## ADDENDUM # 6

To: File 1901-910-23-4878  
QQ for: Villa Tranchese Fire Protection Improvements

**San Antonio Housing Authority  
 Villa Tranchese Apartments  
 307 Marshall Street  
 San Antonio, Texas**

**1 MECHANICAL/ELECTRICAL BASEMENT PLAN – NEW**  
 ME-2B SCALE: 1/4" = 1'-0"

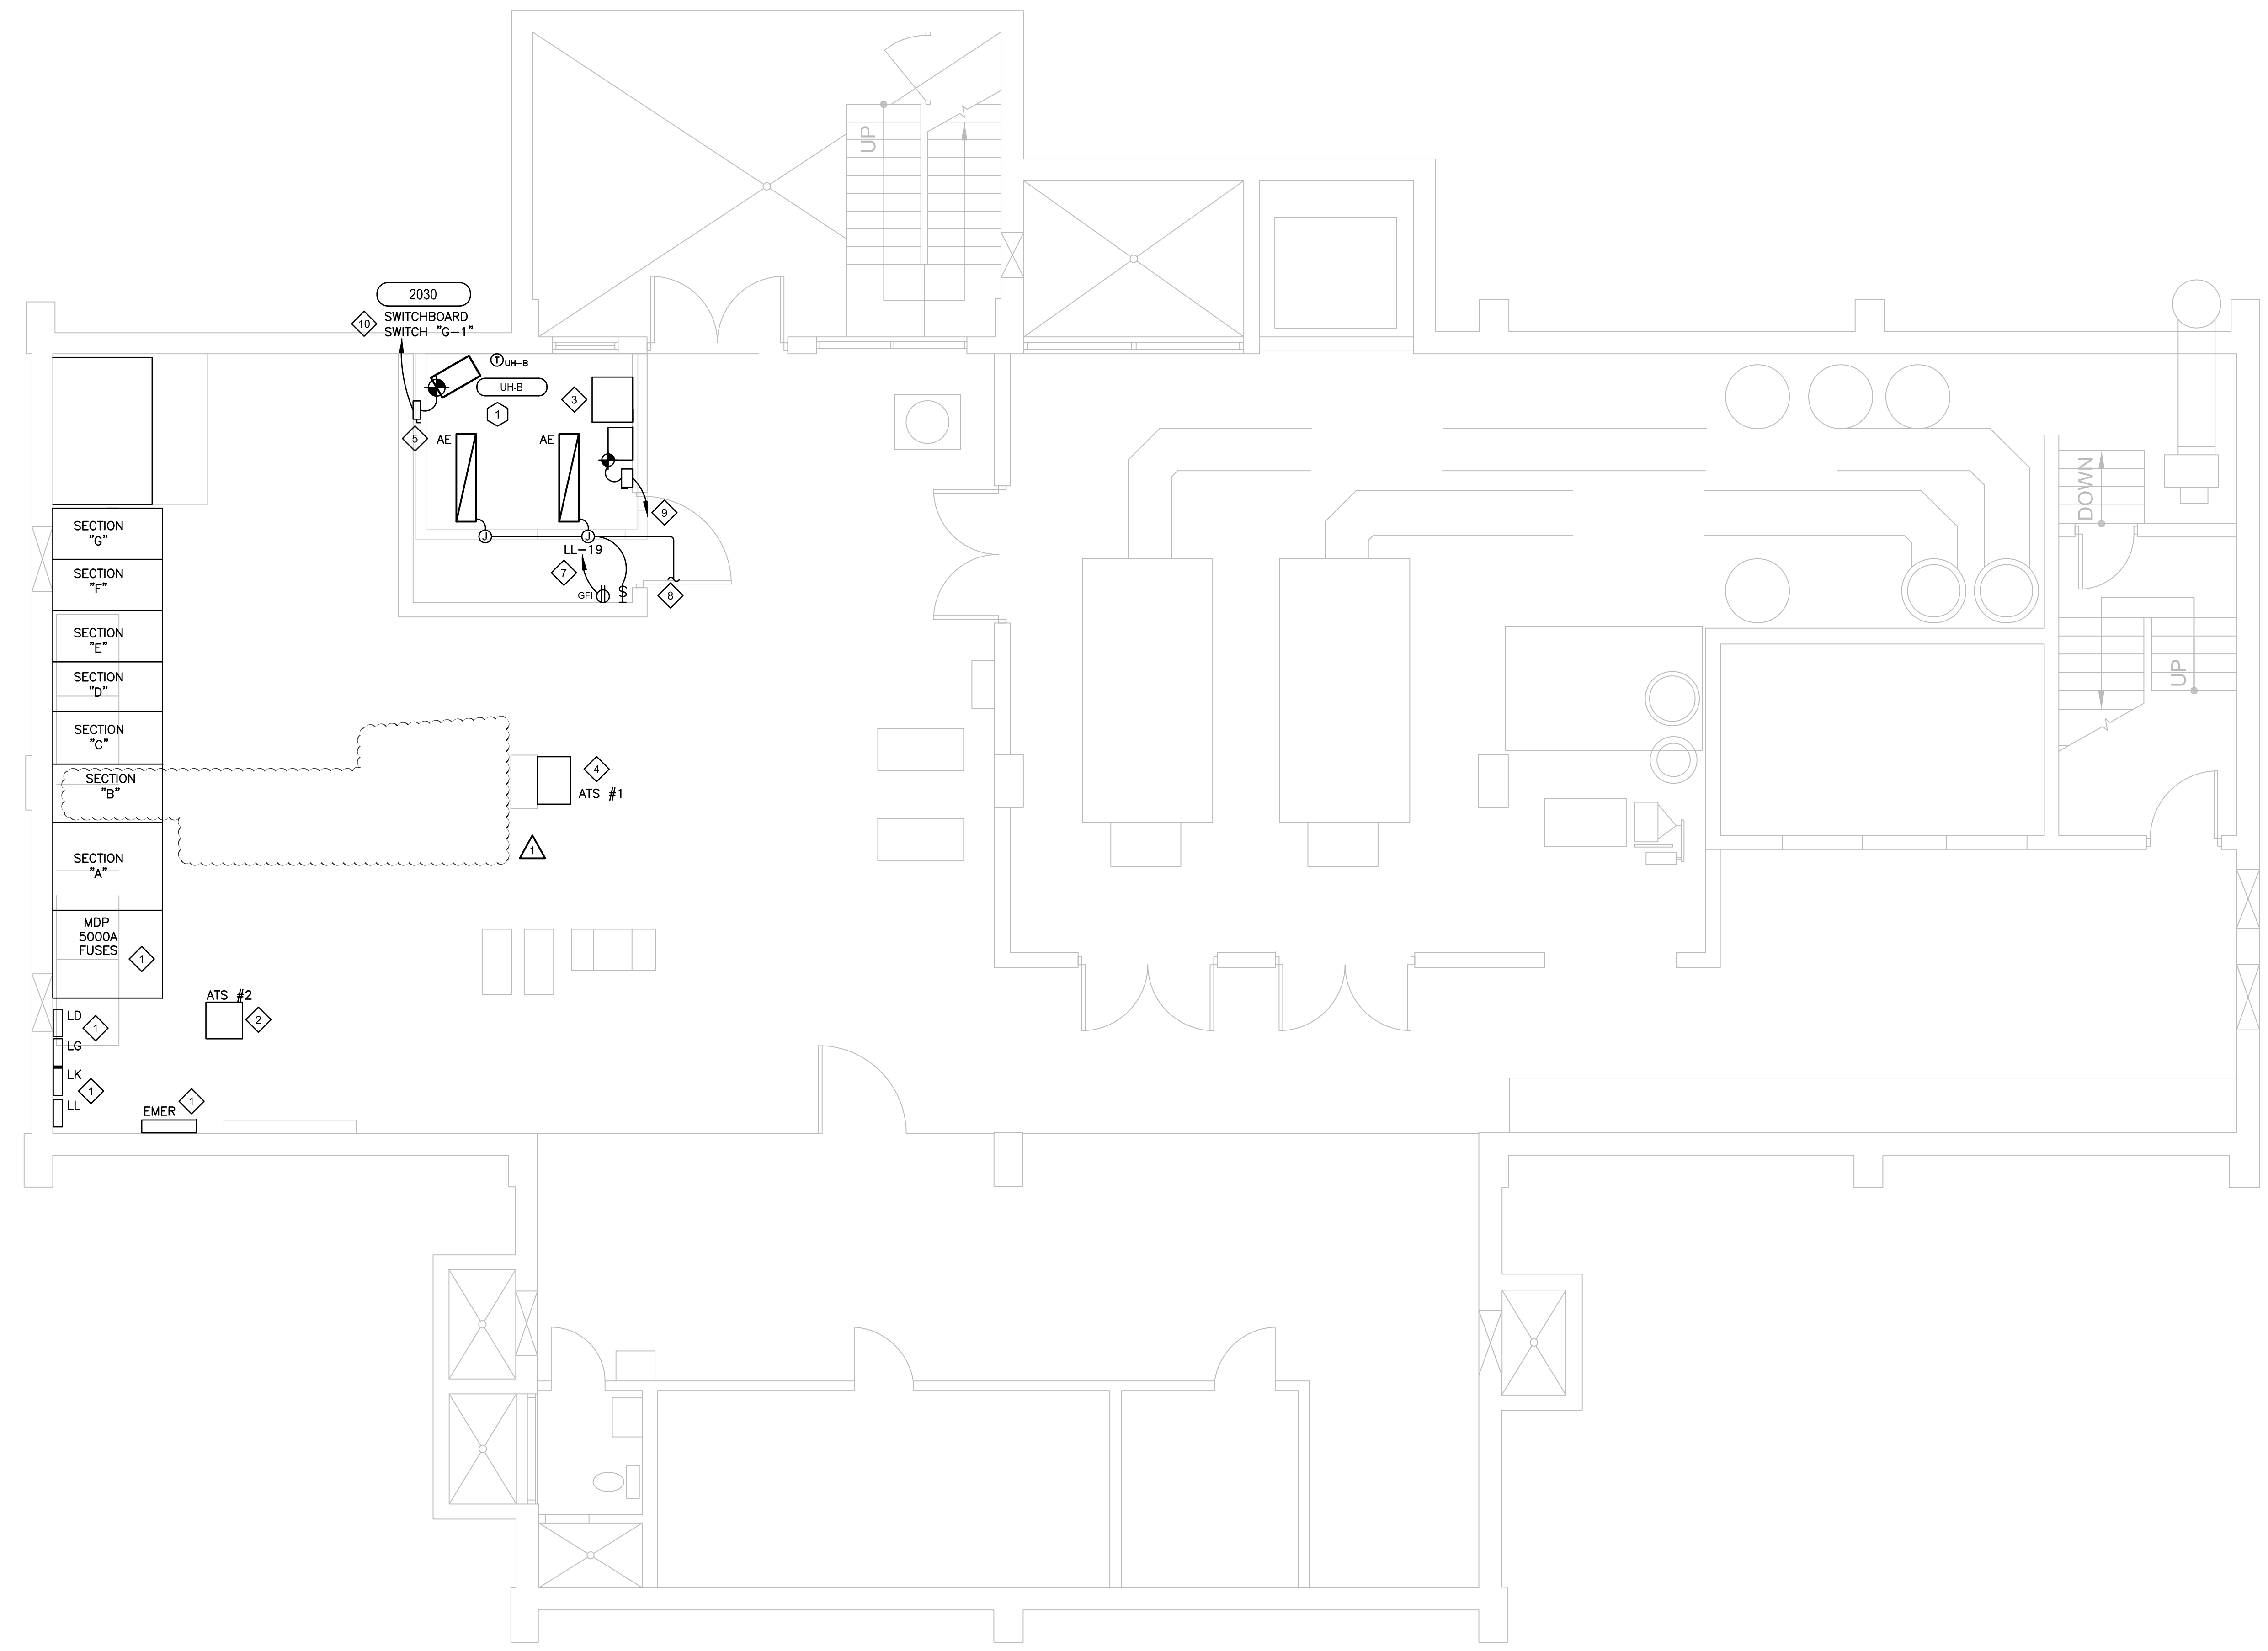
**Question 1:** My electrician just called and he is unclear about information on ME-7B / KN 11 (#4/0 wire going into a 400A disconnect) and ME-2B /KN 11 (a 5000A fully rated switch gear coming out of Section B), plus KN 6 is a bussed duct also coming out of Section B. The gist of the question is: What is inside of the 5000A switchgear and how does it relate to the gutter feeding the fire pump? Several of these details don't seem to match up, and because we are discussing a 5000A switchgear, the inside details are very important and expensive.

**Answer 1:** Refer to attached revised drawing ME-2B for clarification.

1 EXISTING ELECTRICAL EQUIPMENT TO REMAIN.  
 2 EXISTING ATS #2 TO REMAIN  
 3 FIRE PUMP CONTROLLER.  
 4 PROVIDE A 200A, 208V, 3 PHASE, 3W, 3 POLE, WALL MOUNTED ATS. COORDINATE SERVICE OUTAGES WITH SAHA MAINTENANCE DEPARTMENT.  
 5 DISCONNECT SWITCH: 30A/208V/3P/NEMA 1NF.  
 6 NOT USED.  
 7 PROVIDE A 20A/1P CIRCUIT BREAKER WITH 2#12, 1#12 GND IN 3/4" CONDUIT.  
 8 RECONNECT LIGHTING FIXTURES TO EXISTING JUNCTION BOX. FROM JUNCTION BOX, PROVIDE 2#12, 1#12 GND IN 3/4" CONDUIT.  
 9 10 HP JOCKEY PUMP PROVIDED BY OTHERS. REMOVE EXISTING 15A/3P CIRCUIT BREAKER IN SWITCHBOARD SECTION "E-8" AND PROVIDE A 60A/3P CIRCUIT BREAKER. PROVIDE WITH 3#4, 1#8 GND IN 1" CONDUIT. PROVIDE WITH A MOTOR STARTER AND DISCONNECT SWITCH. DISCONNECT SWITCH SHALL BE 60A/208V/3P/NEMA 1NF. SIZE OF MOTOR STARTER SHALL BE COORDINATED WITH JOCKEY PUMP MANUFACTURER AND FIRE PUMP ENGINEER. COORDINATE FINAL LOCATION OF JOCKEY PUMP WITH FIRE PROTECTION ENGINEER

10 REMOVE EXISTING 15A/3P CIRCUIT BREAKER THAT IS IN THE OFF POSITION, AND REPLACE WITH A 20A/3P CIRCUIT BREAKER IN SECTION INDICATED TO SERVE UH-B
